**AGENDA – WORKSHOP OF THE PLANNING & ZONING COMMISSION OF THE CITY OF PEARLAND, TEXAS, TO BE HELD ON MONDAY, JUNE 18, 2012, AT 6:45 P.M., COUNCIL CHAMBERS, CITY HALL 3519 LIBERTY DRIVE, PEARLAND, TEXAS.**

- 1. COMMISSIONER INPUT AND DISCUSSION: REGARDING A PROPOSED PLANNED DEVELOPMENT KNOWN AS PEARLAND'S LAKE PARK – LOCATED AT THE NORTHEAST CORNER OF CULLEN BOULEVARD AND McHARD ROAD. *Presented by Harold Ellis, City Planner***

**AGENDA REQUEST  
BUSINESS OF THE CITY COUNCIL  
CITY OF PEARLAND, TEXAS**

This workshop is to discuss a request for a Planned Development (PD) to be located at the northeast corner of Cullen Pkwy and McHard Road, referred to as Pearland's Lake Park. The property consists of 47.7 acres of land and is currently undeveloped and zoned Single-Family Estate District (R-E). The area being discussed is located just south of where Pearland's City limits abut Houston, and north of Dawson High School.

**Park Amenities (+/- 8.5 acres)**

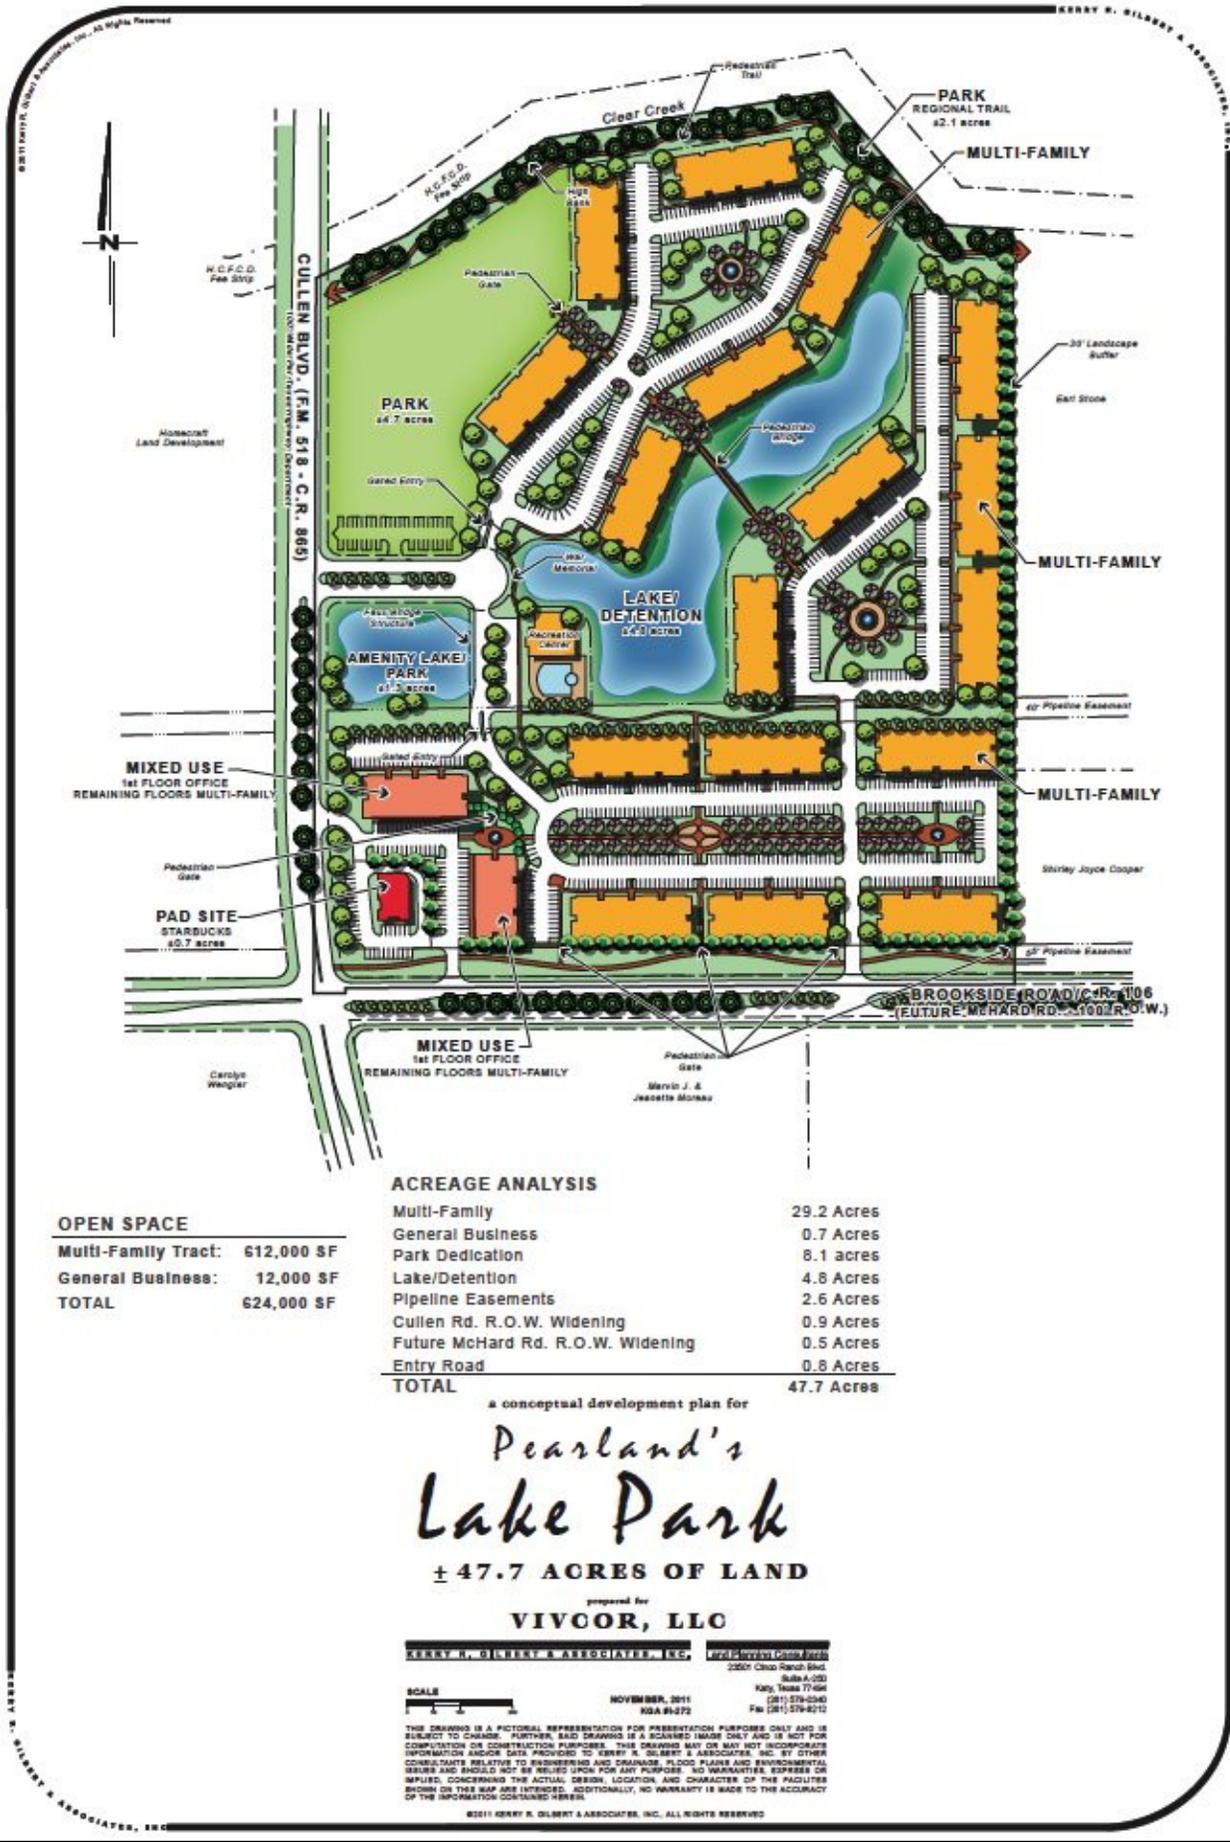
- Please provide breakdown of amenities provided for residents and to the public, and the improvements provided for each.
- Under Park Amenities, please include what type of trees, and style of gazebos.

- No play areas for kids or families?
- Could areas to grill be provided?
- Exercise stations along trail would be a good addition to the amenities.
- Park Amenities – provide details on proposed amenities – specifically water fountains and gazebos.

- The amenity lake at the entrance off Cullen is also referred to as a park – but is not considered a park.
- Acreage of park dedication – based on the number of dwelling units the requirement would be 13.5 acres and only 8.1 are provided.
- Trail setback will need to meet BDD4 requirements, at least 30’.
